ITEM	17
MANAGER'S REPORT NO.	36
COUNCIL MEETING	1978 05 08

Re: PROPOSED REVISION FOR THE SUB AREA
BETWEEN CAMERON AND SULLIVAN STREETS
COMMUNITY PLAN AREA "G"
(ITEM 8, MUNICIPAL MANAGER'S REPORT 4, 1978)

RE: PROPOSED REVISIONS FOR THE SUB AREA
BETWEEN CAMERON AND SULLIVAN STREETS
COMMUNITY PLAN AREA "G"
(Item 8, Municipal Manager's Report 4, 1978)

SKETCH 7

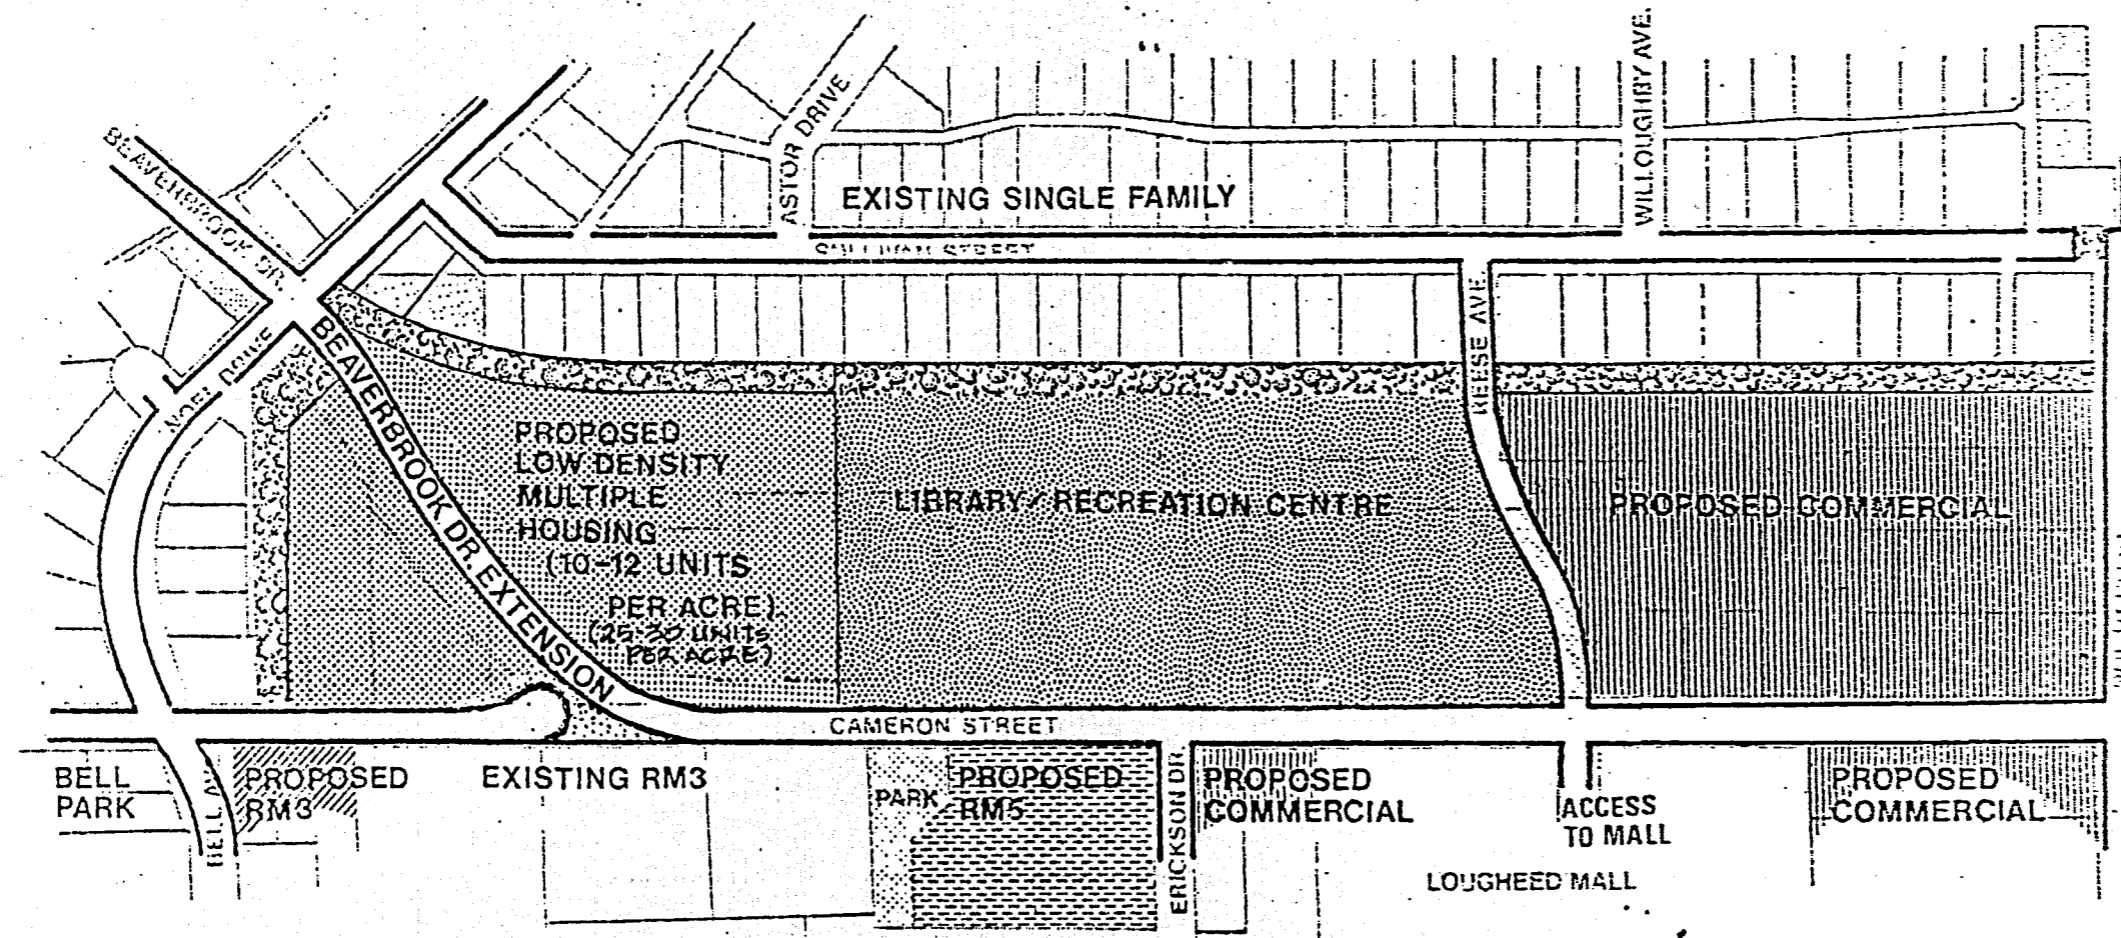
6. As pointed out in the Planning Department's portion of the captioned Manager's report, the Beaverbrook extension to North Road would reduce traffic on Cameron Street west of the mall and also on Noel Drive south of Beaverbrook Drive. This is desirable.
7. As shown in Sketch 7, the widening of Cameron Street to fourteen metres (46') would make the street less desirable for pedestrians.
8. The suggested alignment of Beaverbrook in Sketch 7 would result in the area to the west of the Library/Recreation Centre being divided. Since the possible use of this area for the provision of additional park facilities is currently under discussion between Parks and Planning staff, Alternative 7 is not recommended.

The Commission would therefore recommend the rejection of Alternatives 2 (Sketch 7) and 3 (Sketch 8); and the adoption of Alternative 1 (Sketch 6).
